2405 Nueces Street and 504 W. 24th Street <u>Table of Contents for</u> <u>Heritage Tree Variance Package</u>

ITEM FOR ENVIRONMENTAL COMMISSION AGENDA

OF PROPERTY: 2405 Nueces Street and 504 West 24th Street

CASE FOLDER: TP 182241

Exhibit 1

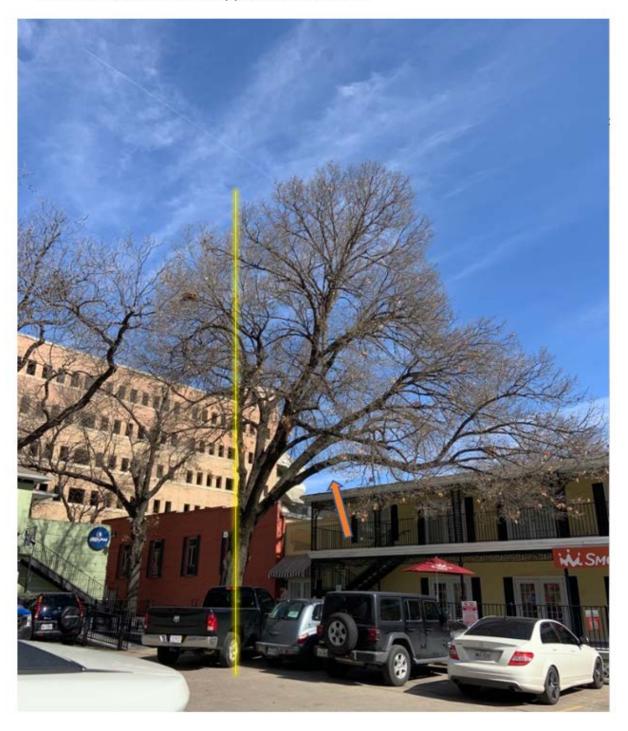
Major asymmetry, unbalanced crown, and an overextended limb (Exhibit 1).

Tree #913: Unbalanced canopy; overextended limb

Exhibit 4

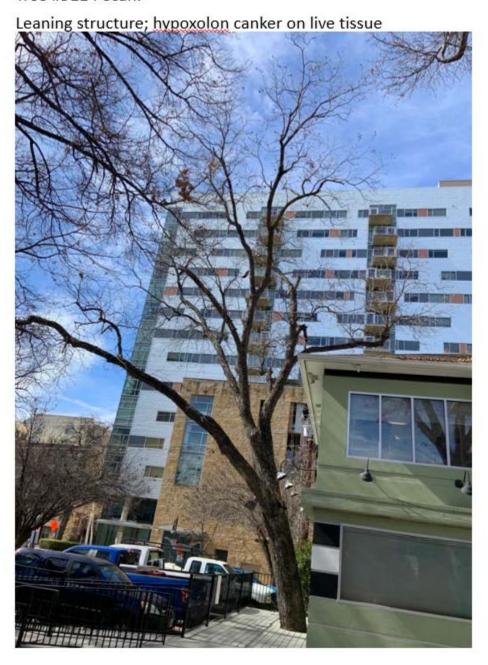
Large cavity in one of the main leaders and hypoxylon canker on live tissue (Exhibits 4 & 5).

Tree #911 Pecan:
